Site Plan 1/16" = 1-0

21-UP-2005
3/20/07

Sereno Canyon

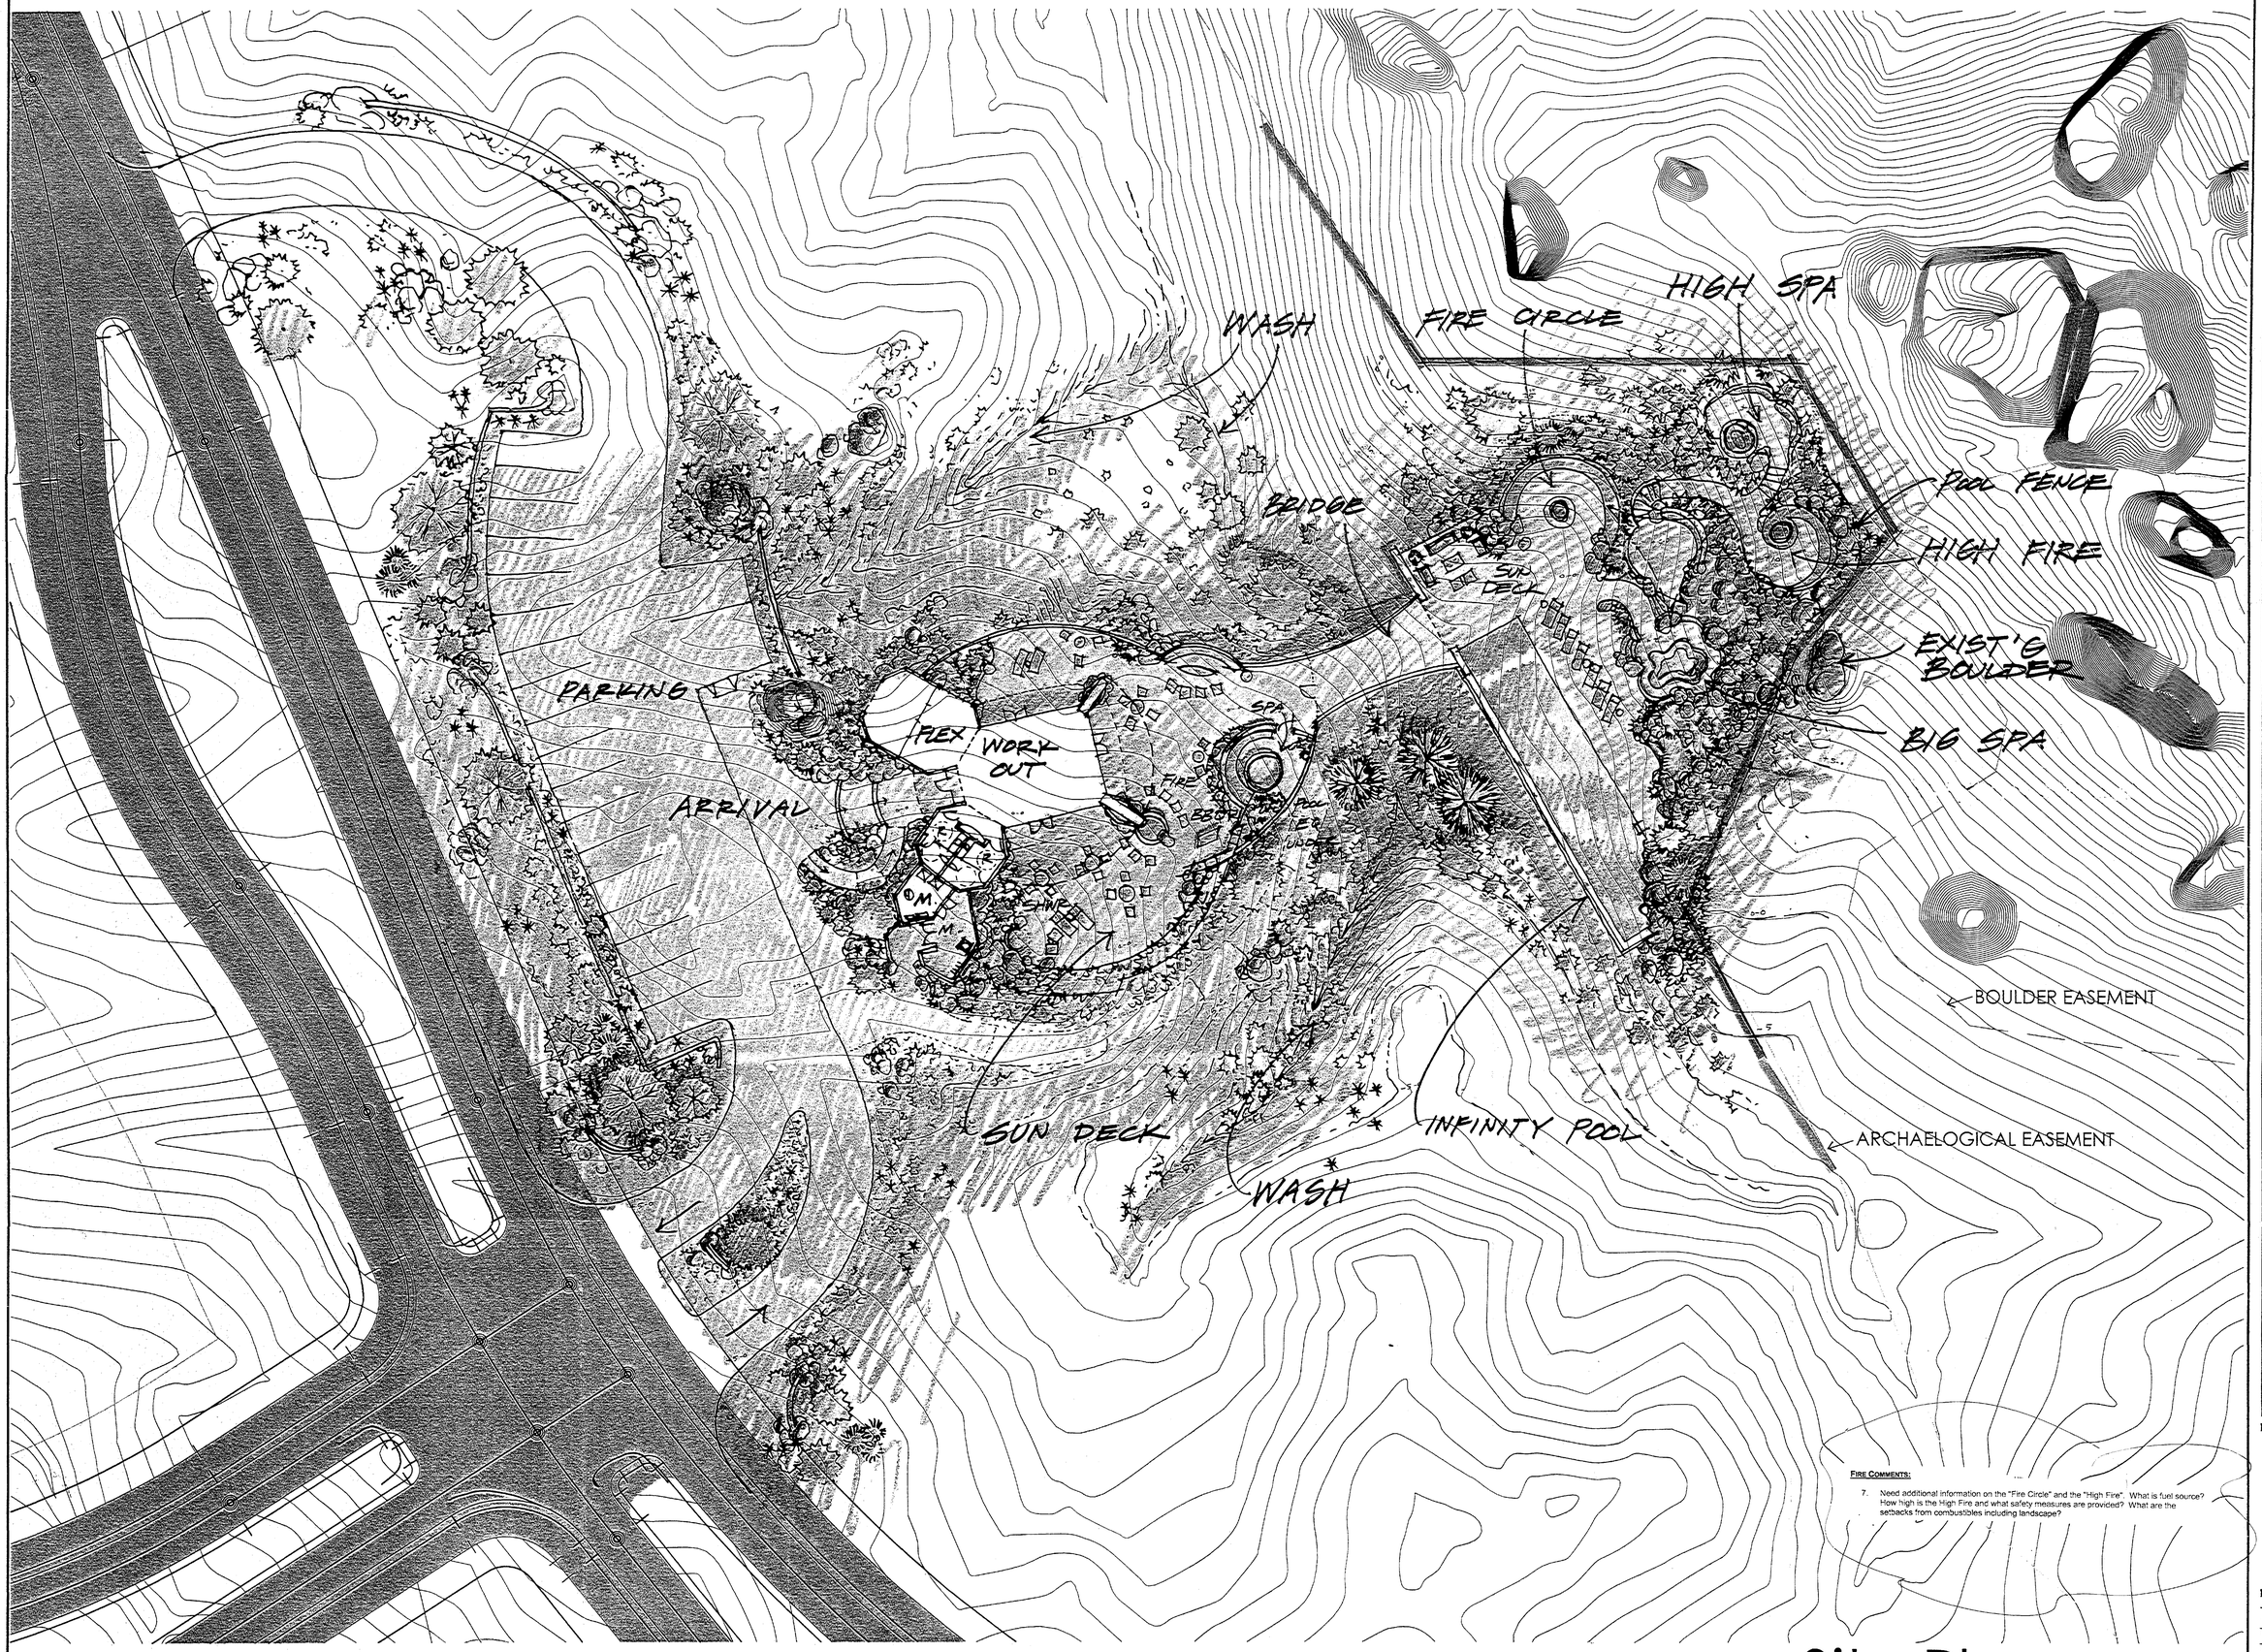
FIRE COMMENTS:

7. Need additional information on the "Fire Circle" and the "High Fire". What is fuel source? How high is the High Fire and what safety measures are provided? What are the setbacks from combustibles including landscape?
